Service Bulletin

Bulletin No.: 24-NA-129

Subject: Water Leak from Around Windshield Area

Brand:	Model:	Model Year:		VIN:		Engine:	Transmission:
		from	to	from	to		
BrightDrop	Zevo 400	2024	2024	-	-	All	All
	Zevo 600	2023	2024

6688566

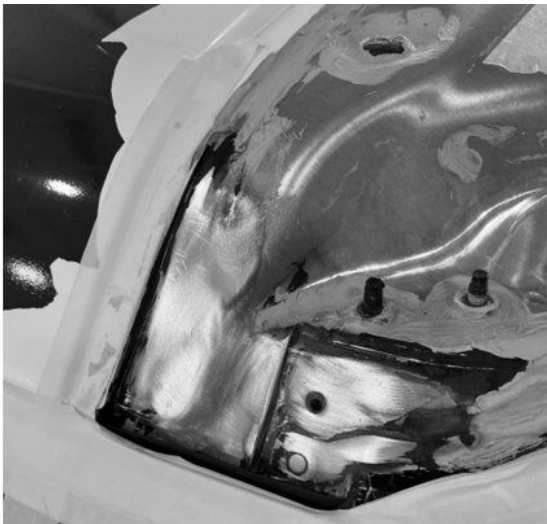
3. Air bubble test using soapy solution and air gun to confirm the rat hole is the cause of the leak.
4. Clean and prep both sides of the vehicle. Wipe aluminum surfaces with Kent Acrysol, P20005, or equivalent, to remove any residual sealer or urethane. Wipe down all aluminum surfaces with 70% Isopropyl Alcohol.

Illustration above shows un-prepped surface with old sealer present.
